Subject: Docket Nos. 50-361 and 50-362  
San Onofre Nuclear Generating Station  
Units 2 and 3

# POTENTIAL FINDING REPORT SONGS 2&3 SEISMIC DESIGN VERIFICATION

PFR NO. 2402-PFR-0009

AFFECTED ITEMS: Seismic Class I Cable Tray Supports  
Tray Hanger No. 37183 Ref: Calculations No. C270-01-02  
Sheets 360 - 365

NATURE 7.11.71 DATE 8-22-70 CHECKED John DATE 11-2-70  
 SUBJECT BRACE JOB NO. 10074  
 DET BRACE SHEET 5 OF 5

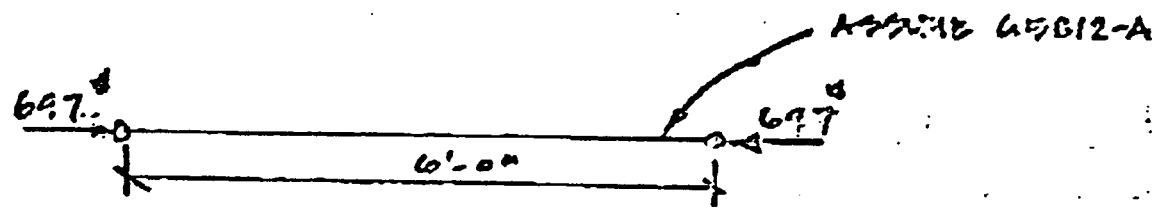
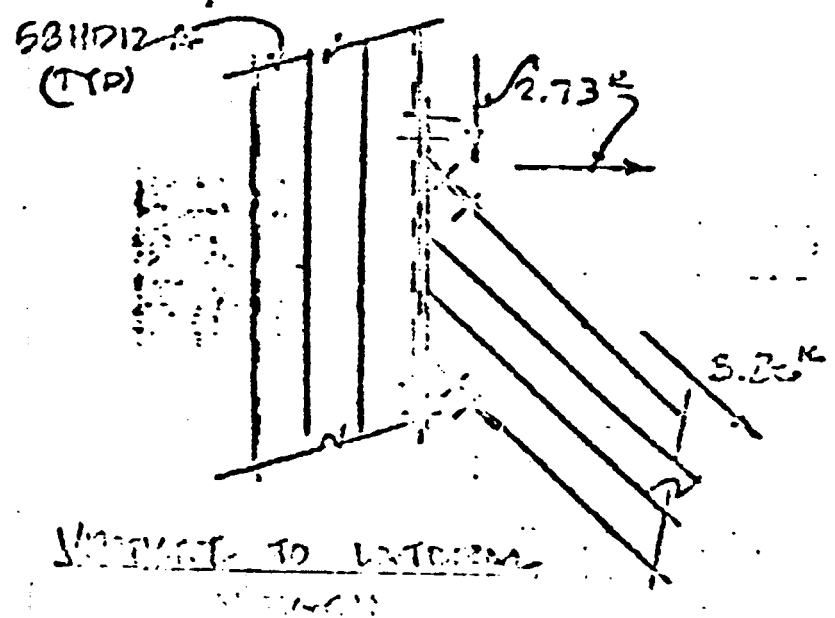
Axial load on lateral brace was calculated to be 3860 pounds (Sheet 361). Allowable  
pull-out load on brace connection is only 3290 pounds (Sheet 364).  
Therefore, the applied load, as calculated, exceeds the permissible load.  
See Attachment 1.
